ARLINGTON, VA

FBC ADVISORY WORKING GROUP MEETING
FOR YW CAPITAL DEVELOPMENT

02/11
2020

APPROVED GROUND FLOOR PLAN

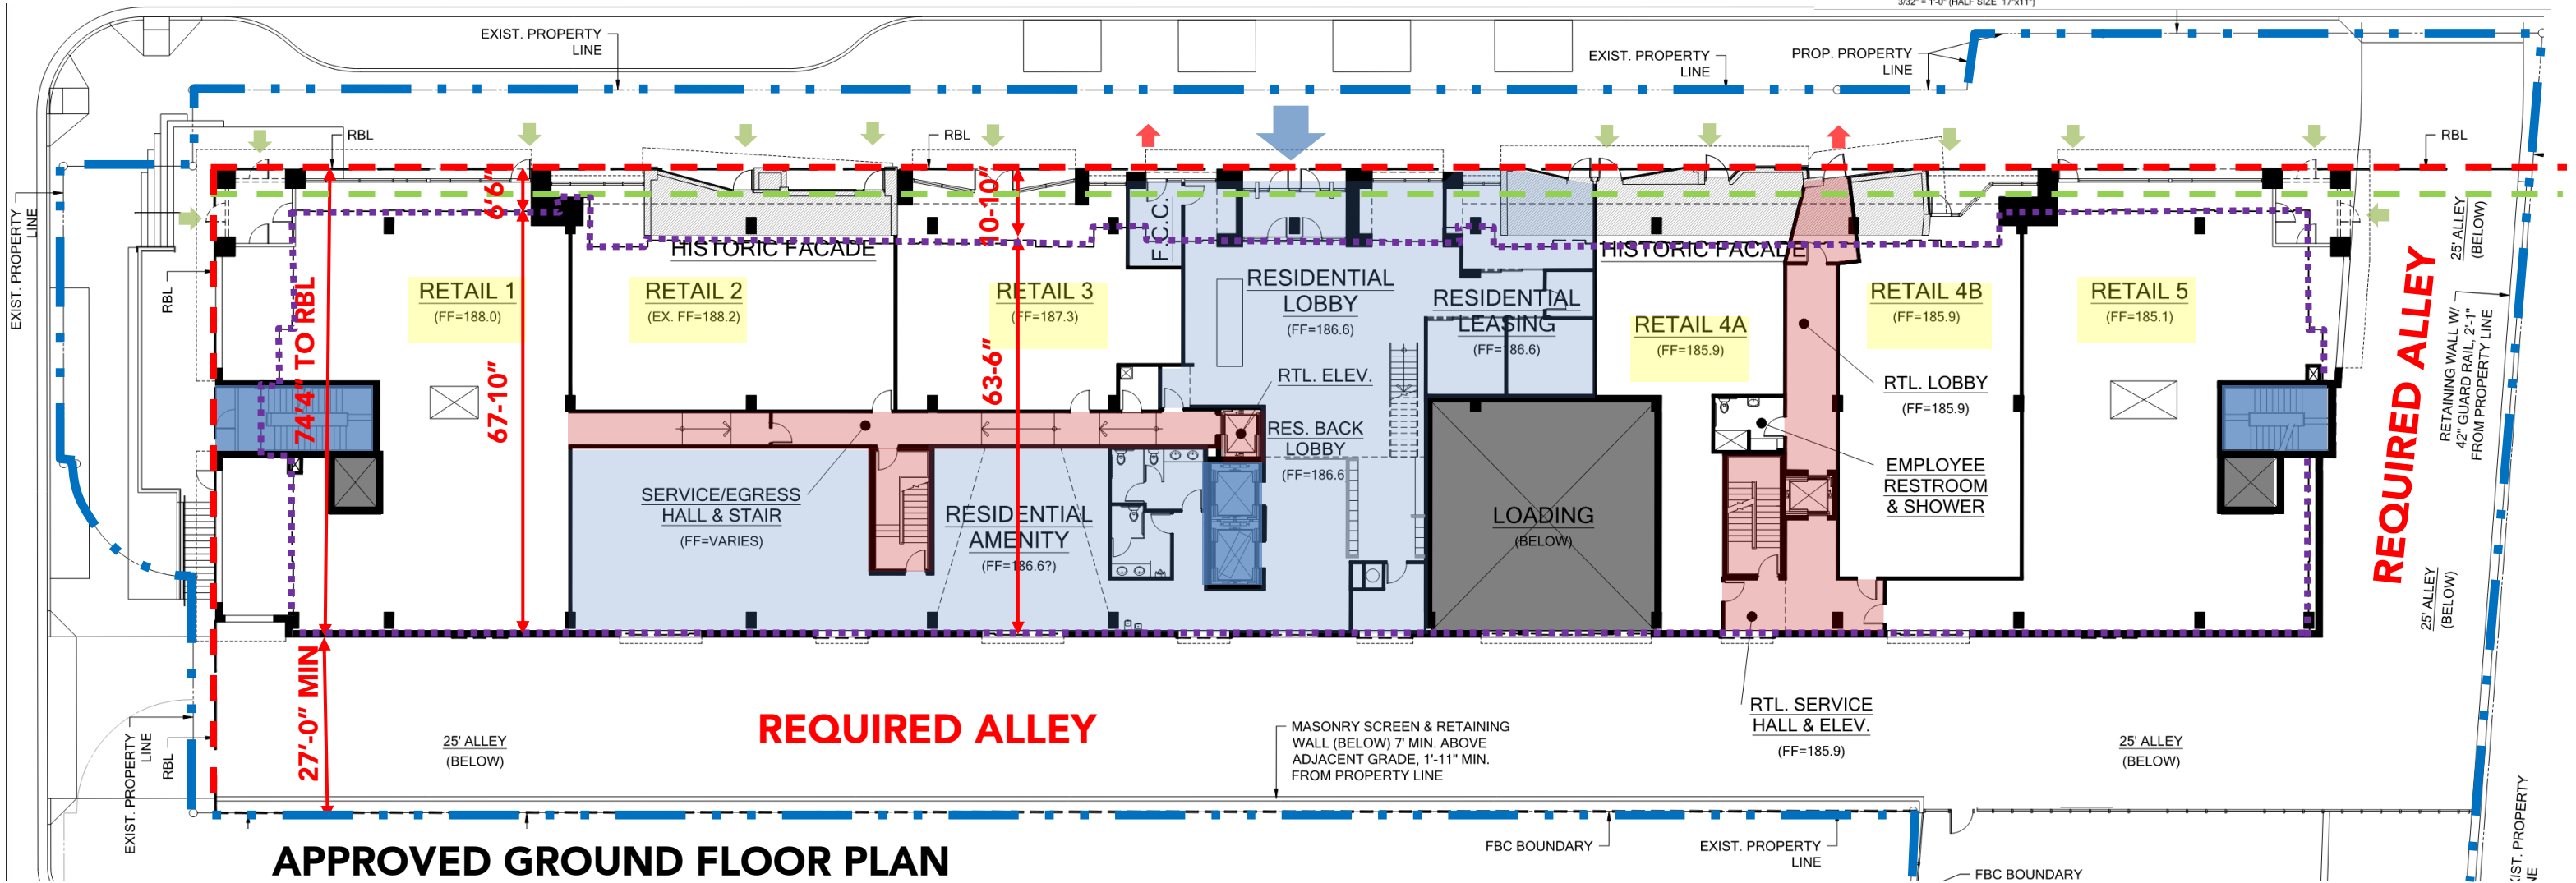
APPROVED BUILDING CHALLENGES

- 6 DISTINCT RETAIL BAYS (NO FLEXIBILITY)
- 6 SLAB ELEVATIONS
- SHALLOW RETAIL BAYS
- RETAIL DIVIDE BY RESIDENTIAL USE
- 4 STAIR CORES / 3 ELEVATOR CORES
- MINIMUM PARKING REQUIREMENT DOES NOT MEET REALISTIC RETAIL NEED.
- EXTREME UPPER LEVEL SETBACKS FROM RBL

FAÇADE & DESIGN CHALLENGES:

- LARGE CANTILEVERING "FRAME" AT PARAPET
- FORCED SYMMETRY
- PROTRUDING STAIR TOWERS
- NO BALCONIES
- EXTREME UPPER LEVEL SETBACKS FROM RBL

**GROUND STORY AND
SITE PLAN COMPARISON**

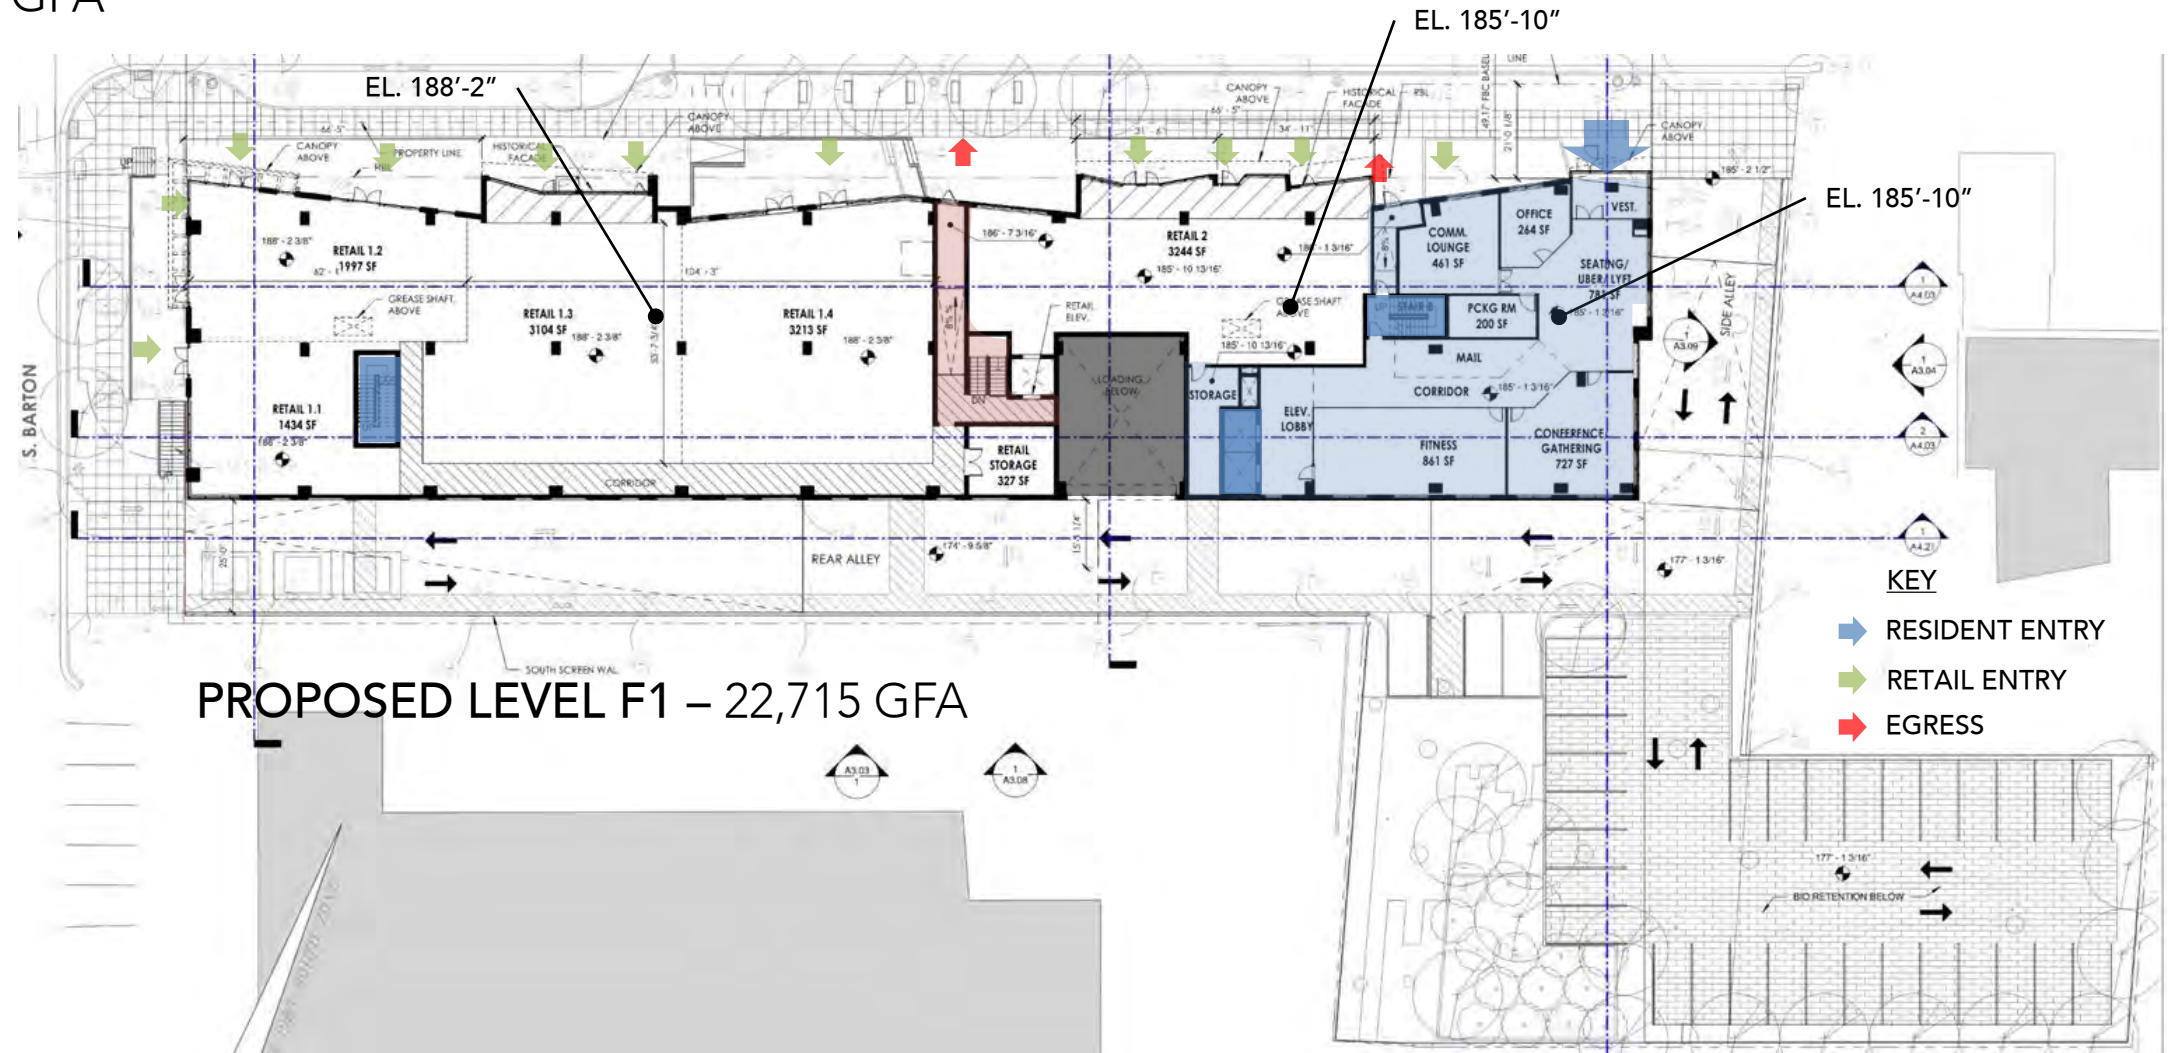
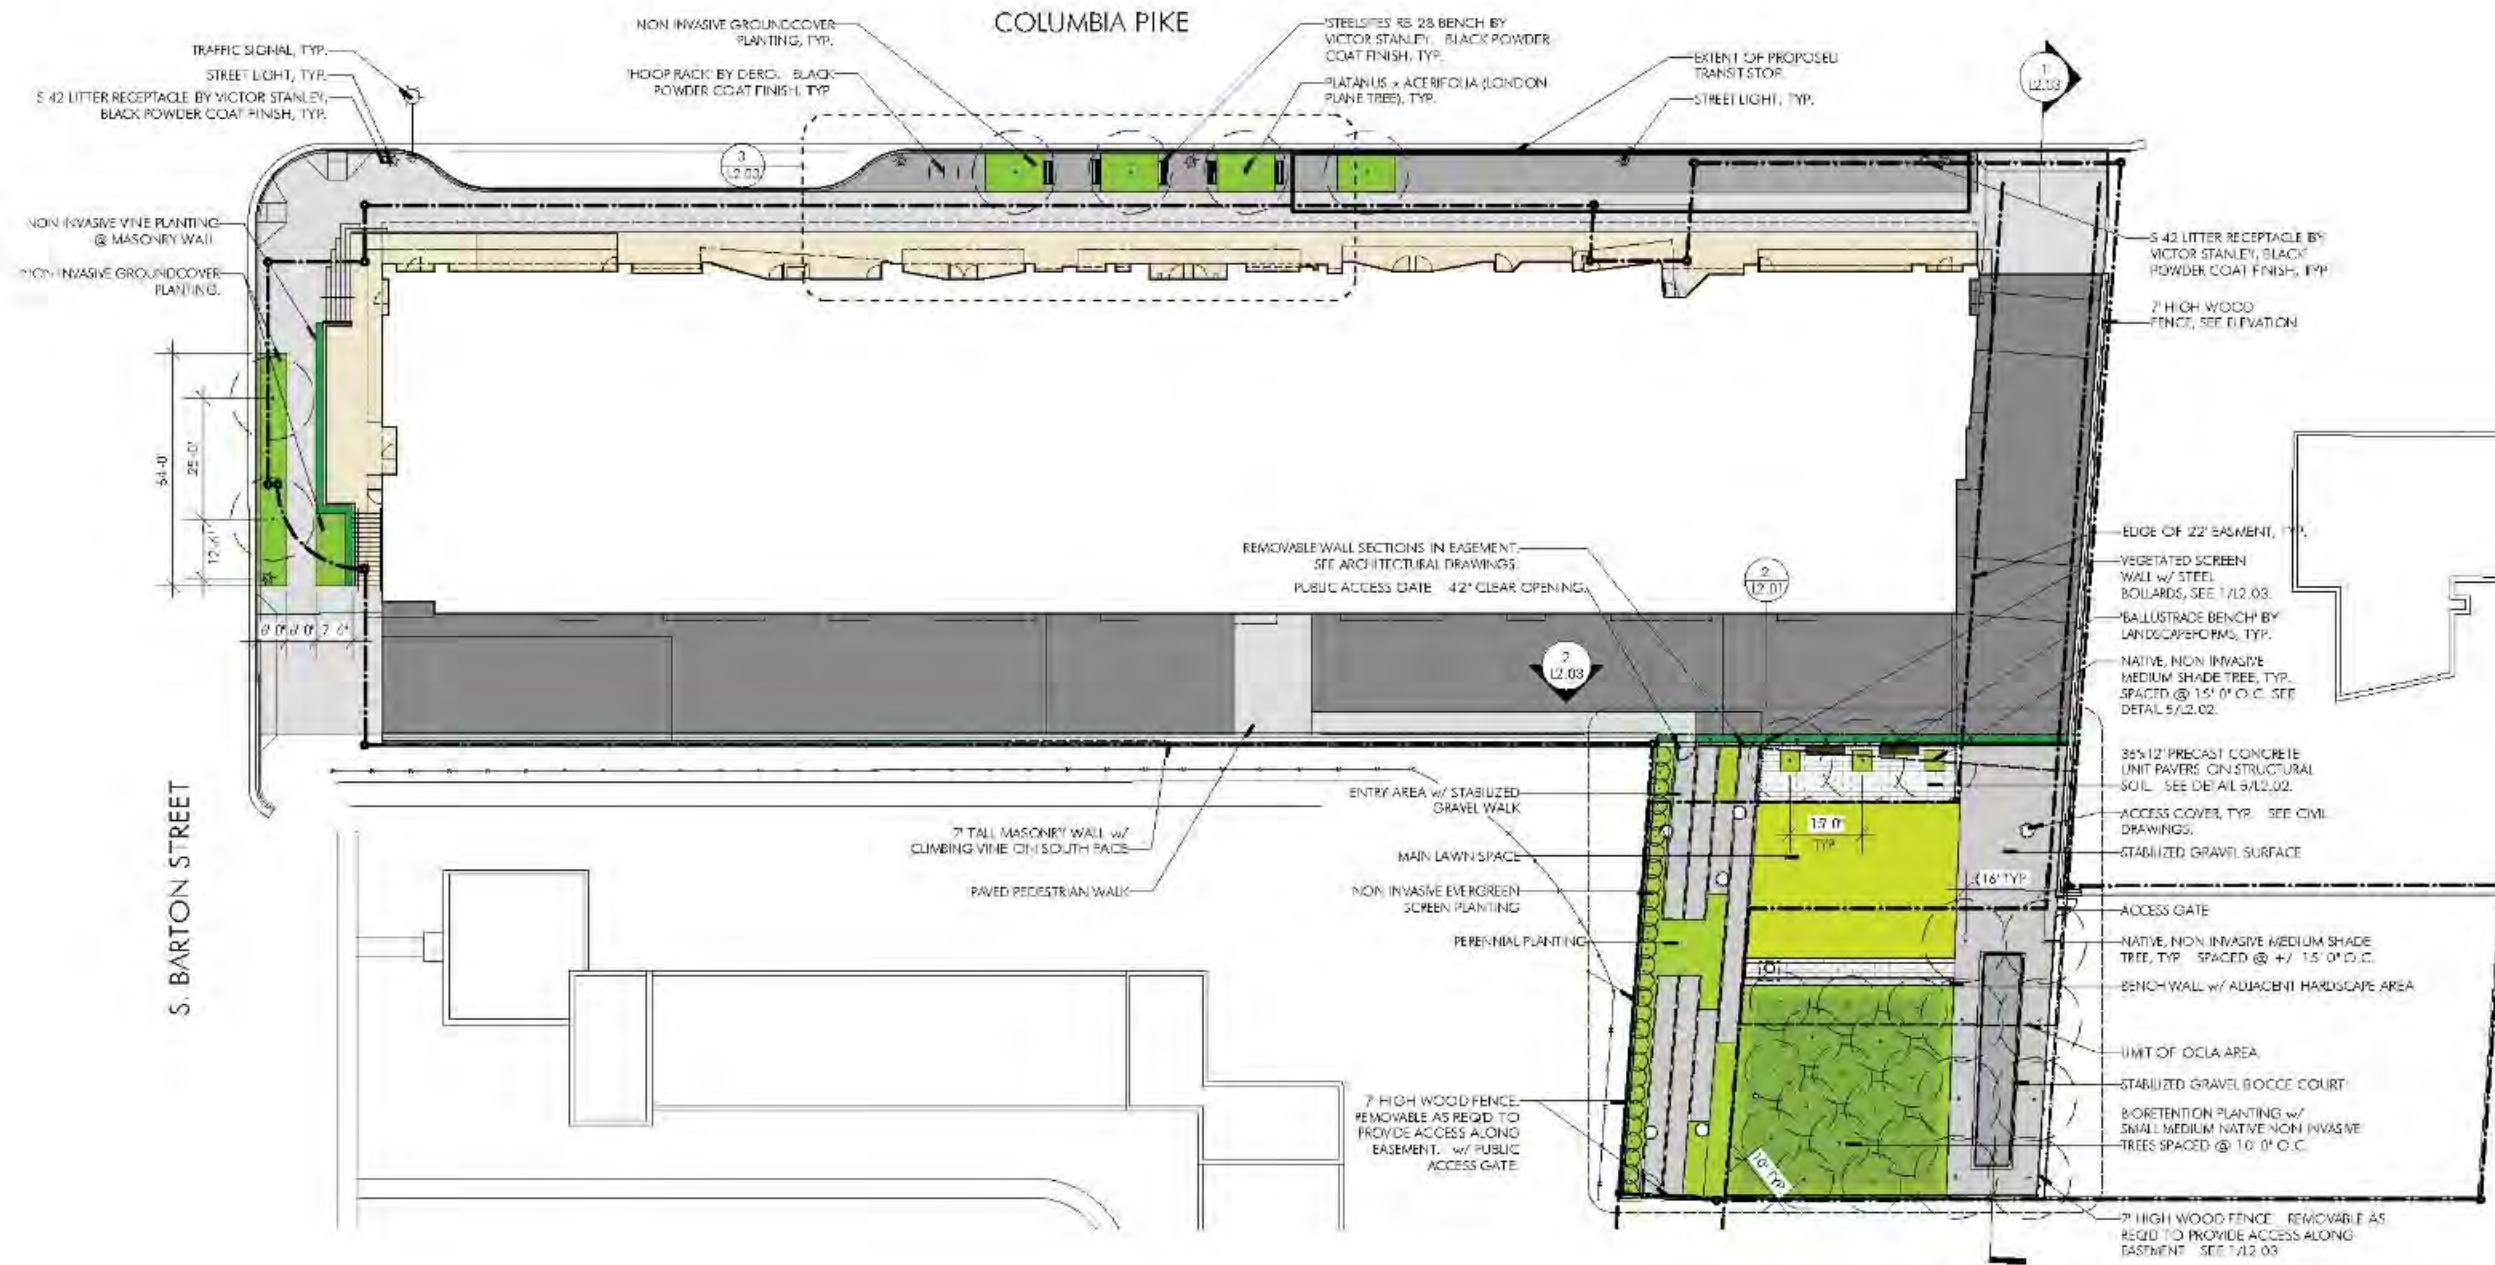
- RETAIL**
- TOTAL 14,233 SF
 - RETAIL DEPTH: VARIES
 - (5) RETAIL FLOOR ELEVATIONS

- RETAIL**
- TOTAL 15,800 SF
 - RETAIL DEPTH: 60'-0" TYP.
 - (2) RETAIL FLOOR ELEVATIONS

Exhibit 9a: Proposed modification for height of finished floor elevation on S. Barton Street

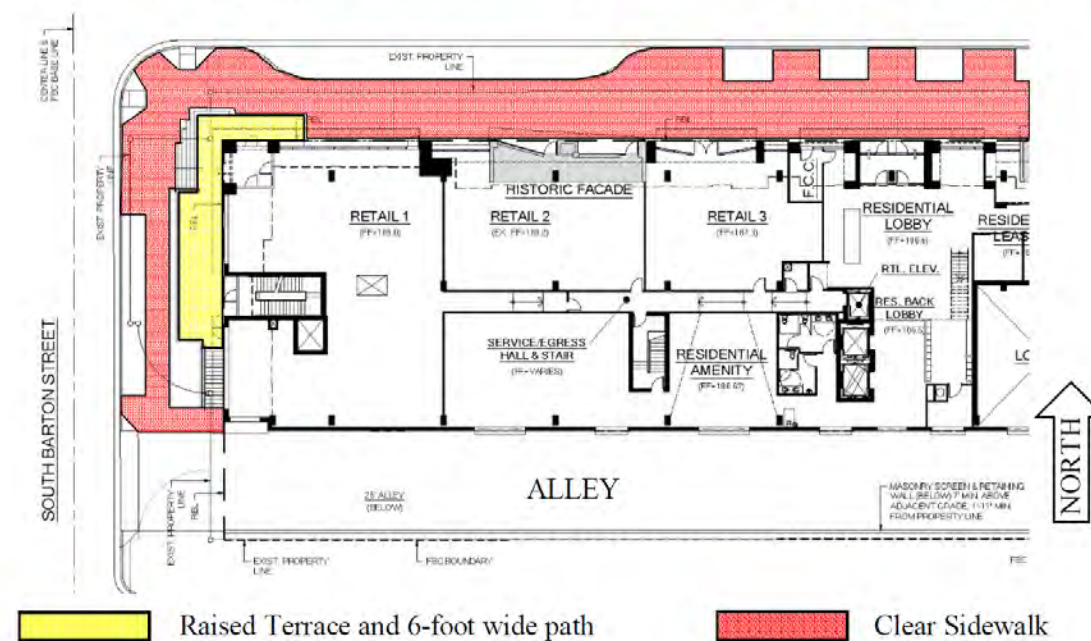
Proposed Modification #1: Height of finished floor elevation for ground-story retail along S. Barton Street. The Building Envelope Standards for Main Street buildings require all ground story elevations to be between six inches below and 24 inches above the sidewalk elevation at the front of the building. Ground stories also include minimum clear heights of 15 feet which have to be accommodated for at least 1/3 of the area along the Required Building Line (RBL). These requirements apply to all ground floor retail spaces along each RBL. The proposal is compliant along Columbia Pike, however, due to the significant change in topography along S. Barton Street and a shallow area between Columbia Pike and the alley for the building floorplate, the applicant proposes to construct the ground story retail at a uniform finished floor elevation that is level with the Columbia Pike frontage. Therefore, the ground story will exceed the permitted maximum 24" dimension relative to the fronting (S. Barton St) sidewalk by a range of two feet near Columbia Pike and six feet near the southern alley (see Exhibit 9a).

If the proposal were to comply with the existing regulations, the 65' wide floorplate would have to be divided into approximately three separate bays, stepping down from Columbia Pike, to meet the average sidewalk grade along S. Barton Street. That design would also require extensive internal ramping within the service corridors to access the rear of the retail units.

Instead, the proposed design avoids the need for this significant internal ramping from the interior service corridors and increases the overall amount of leasable space by accommodating these additional service functions in a more efficient manner. The proposed design will provide more flexibility in attracting a wider range of retail tenants and will include a raised terrace in front of this retail space to mitigate any impacts on the adjacent streetscape. The raised terrace will provide an opportunity for outdoor seating that would otherwise not be available and represents an element supported by community members.

PROPOSED MODIFICATION #1 (PREVIOUSLY APPROVED):
FINISHED FLOOR ELEVATION FOR GROUND FLOOR RETAIL

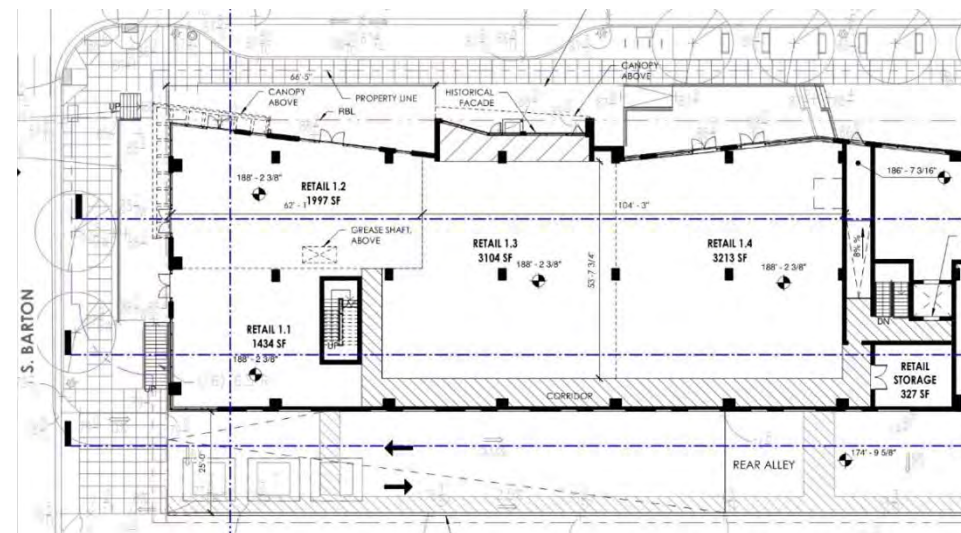
It is not feasible to meet Ground Story elevation requirement due to significant change in topography along S. Barton Street,
